PCN# : P59BAAB
Issue Date : Sep. 10, 2015

Information Only Notification

Description of Change (From) :

Figure 9. Maximum Safe Operating Area

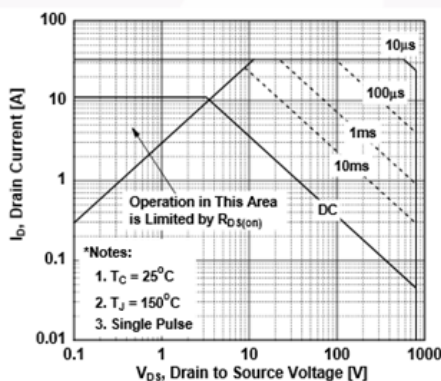
- 1) Sub Title: 800 V, 11 A, 400 m (page 1)
- 2) Absolute Maximum Ratings, Note - *Drain current limited by maximum junction temperature (page 1)
- 3) Absolute Maximum Ratings, I_D , Drain Current (Continuous $T_C=25^\circ\text{C}$) = 11 A (page 1)
- 4) Absolute Maximum Ratings, I_D , Drain Current (Continuous $T_C=100^\circ\text{C}$) = 6.9 A (page 1)
- 5) Drain-Source Diode Characteristics, I_S = 11 A (page 2)
- 6) Current Figure 9, Maximum Safe Operating Area (page 4)
- 7) Current Figure 10, Maximum Drain Current vs Case Temperature (page 4)

- 5) Drain-Source Diode Characteristics, $I_S = 14$ A (page 2)
- 6) Updated Figure 9, Maximum Safe Operating Area (page 4)
- 7) Updated Figure 10, Maximum Drain Current vs Case Temperature (page 4)

Drain Current values being updated as updated calculations of TO220 package with heatsink R_{thjc} support the new values as shown in updated Figures 9 and 10.
